Sheringham Shoal and Dudgeon Offshore Wind Farm Extension Projects

The Applicant's Comments on Post-Hearing Submissions

Revision A
Deadline 4
May 2023
Document Reference: 18.14

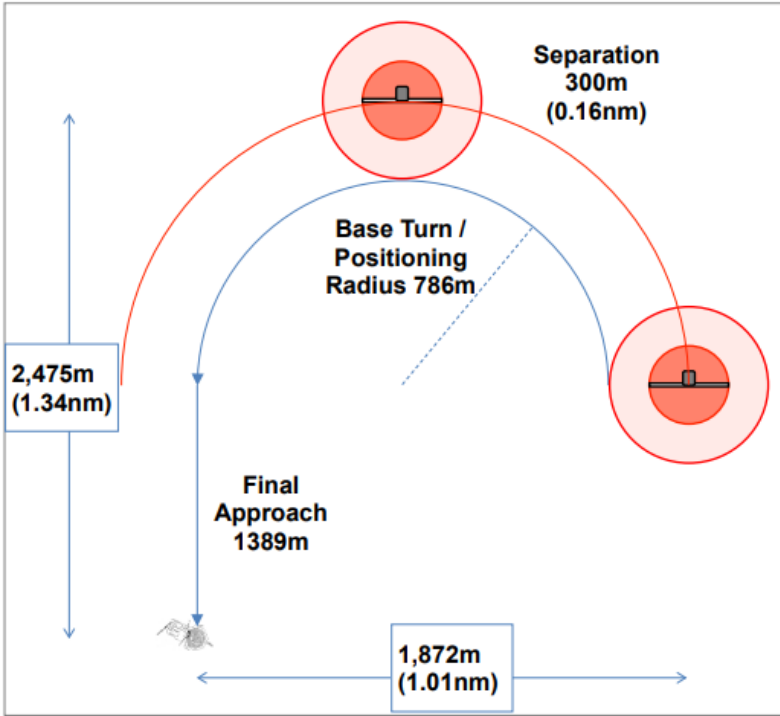
2.4 LINK 57		
55	OPC also raised LINK 57 Blickling Rd and that there is the possibility of a cumulative impact from Vattenfall's LINK 75, which will also access this road from the B1149. The Applicants have stated that they are able to close the road for 15 mins in every hour if required along this link road. It should be noted that Link 57 is also the main access route to Blickling Hall from the Saxthorpe roundabout and is signposted as such (a brown tourist sign).	<p>With regards to comments on cumulative impacts along link 57, the Applicant refers to its previous response to this question provided in response to ID60, Table 1-2 of The Applicant's Comments on Post-Hearing Submissions [REP2-043].</p> <p>With regards to closing a road for 15 minutes in every hour, the Applicant clarifies the Outline Construction Traffic Management Plan (Revision C) [REP3-062] outlines a 'range' of measures that could be adopted to allow HGVs to pass along routes of restricted width. One of these measures is a "Temporary obstruction' signage to hold traffic (for up to 15 minutes with a subsequent gap of at least one hour) whilst HGVs travel along routes". The OCTMP also notes that the final choice of measures will be agreed with NCC.</p> <p>Notwithstanding, the B1145 (link 57) is not identified as a route where these measures would be required and the Applicant confirms that residents will still be able to access their properties.</p>

56	OPC seeks clarification from the Applicant that there will not be a cumulative impact between Vattenfall and Equinor along this route, and that residents will still be able to access this road to their properties.

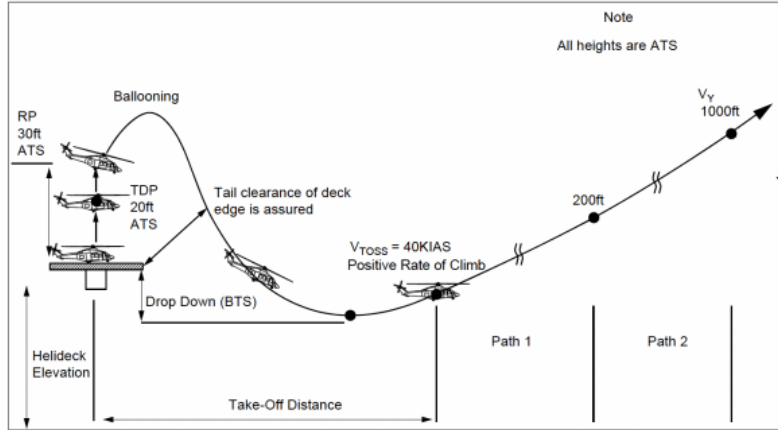
2.1 Waveney Platform [REP3-156]		
3	As the Waveney platform does not have accommodation facilities other than for emergency use, for work to be undertaken at the Waveney platform two flights for normal maintenance operations (i.e. excluding "rotors running" production restart visits) are required within the same day with sufficient time between the flights to enable work to be undertaken. If the forecast indicates that a second flight is unlikely to be possible, the first flight will not be undertaken. Based on operational experience to date, such work only occurs approximately weekly. Both flights need to occur within daylight hours. Flights are possible as long as the minimum conditions for daylight operations under Instrument Flight Rules (IFR) are met.	Agreed.
